**ADDENDUM #8
BID NO. 2009-W**

Project: Ellisville Water System Improvement – Expansion to I-75 North

Response to Request for Additional Information #2

**RE: Ellisville Water System Improvement
Expansion to I-75
Request for Additional Information #2**

**SINGLE WATER
SERVICE CONNECTION**

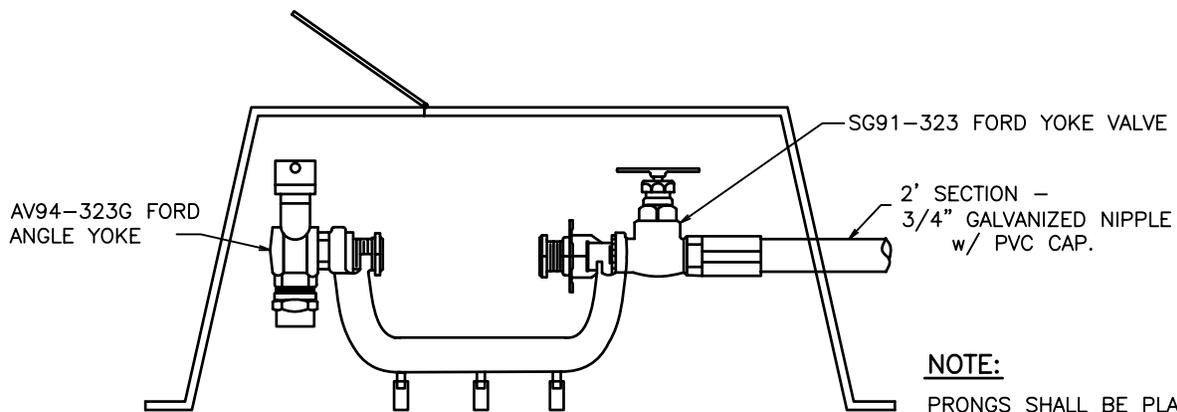
6. Please provide information on the services required on this project.

A detail and specification for the water services is attached to this memo.

A. The service line shall be 3/4" in size from the tap to the road right-of-way.

B. An EMS marker, Scotchmark #1257, shall be buried behind the buried angle meter valves. A 2 inch PVC pipe will be set vertically atop the angle meter valve and shall extend 2 feet above grade.

C. The angle meter valves shall be Mueller B-24273 or Ford AV94-323G.

D. Service taps shall have a minimum 7/8" (opening cut) in the saddle clamp. Saddle clamps shall be Romac Style 202N, double strap, nylon saddle with stainless steel straps, with cc tap. (Single strap saddle clamps prohibited).

G. Service lines shall have a minimum of 30" cover in the roadway areas and 30" cover in the ditches.

H. Service piping shall be polyethylene tubing meeting requirements of the National Sanitation Foundation and dimensional tolerances of ASTM B88-55 and AWWA 75-CR. Piping connections shall be made by the compression method. Tubing shall be pressure rated at 160 psi.

I. Service take-off from mains shall be made from the top quadrant of the main axis no more than 45 degree incline from the vertical.
